# Recall Campaign

NHTSA#: 13V-028

Replace wiper arms

**2011 Class A Motor Homes**

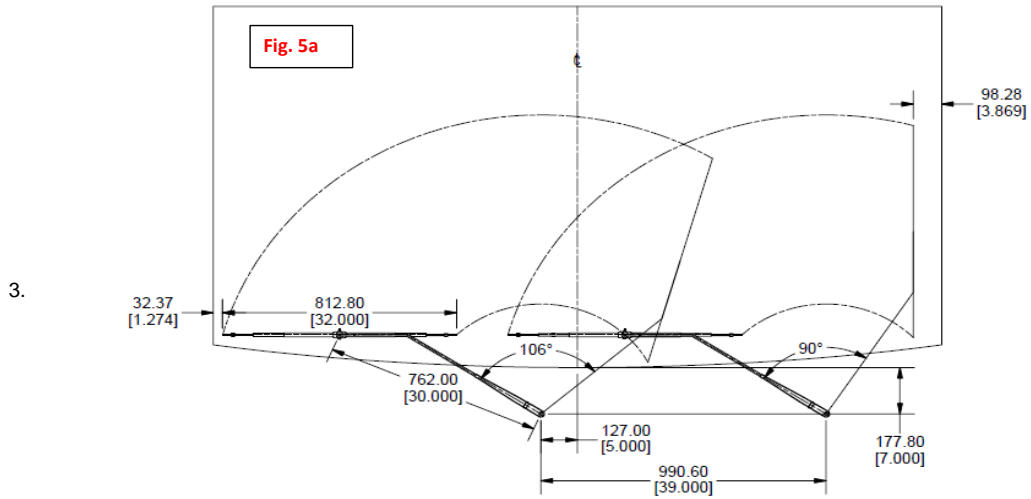
- Place the spherical ball over the lever stud and apply grease (grease packets are supplied with the kit) on top of the spherical ball on the passenger side lever. Grease should also be applied on the motor drive arm pin prior to installing the link back on the motor drive arm.

- Install the new link onto the drive arm pin and the pivot lever pin. Install the spherical washer(s) and the spherical nut(s). Tighten the spherical nut(s) on the center joint and the pivot lever pin to 5-7 foot pounds.
